Applicant: Lectrosonics, Inc.
581 Laser Road
Rio Rancho, NM 87124

Re: Response to Correspondence reference number 31725

Equipment: FCC ID: DBZUM450H, 731-confirmation number EA248053

Photograph showing separation distance from the back of equipment to the antenna.

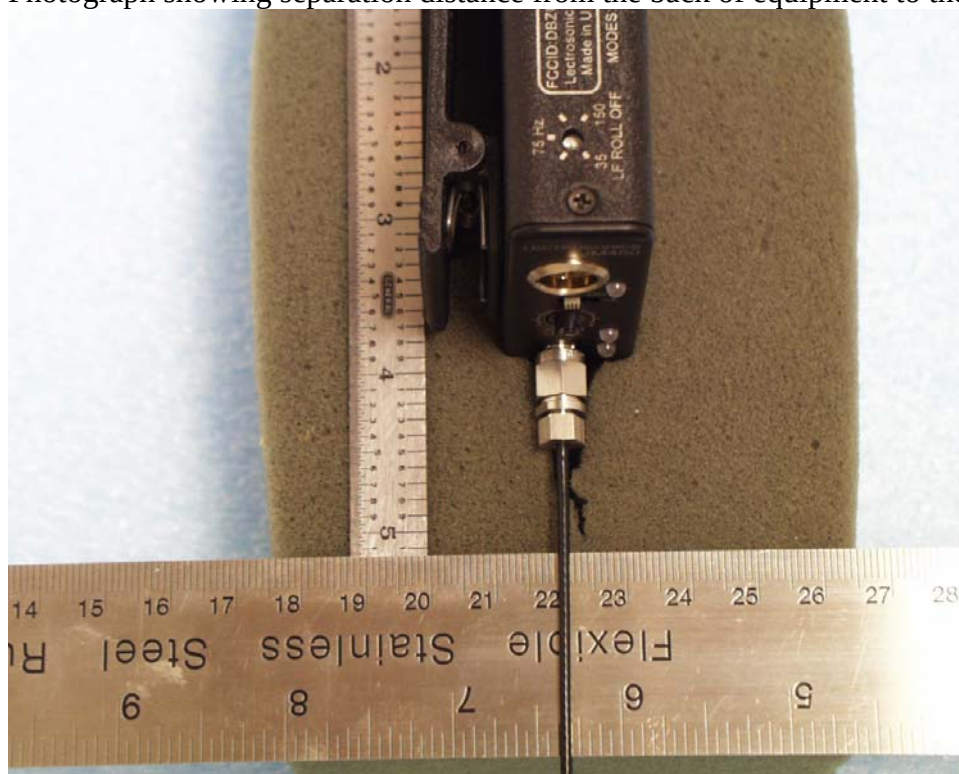
To support FCC RF exposure compliance determination, please submit photos and/or sketches for product with antenna installed showing spacings between the plane of the back of the belt-clip to: a) the back of the device, b) the closest point(s) of installed-antenna(s) FCC will then review all filing info to determine whether other info may need to be requested to support compliance with RF exposure requirements as applicable for all transmitters regulated by FCC. It may help to expedite this review if applicant has available and wishes to voluntarily submit SAR test results for this specific product

Below please find relevant photographs per your request demonstrating spacing between the back of the device and antenna, and the back of the clip and antenna.
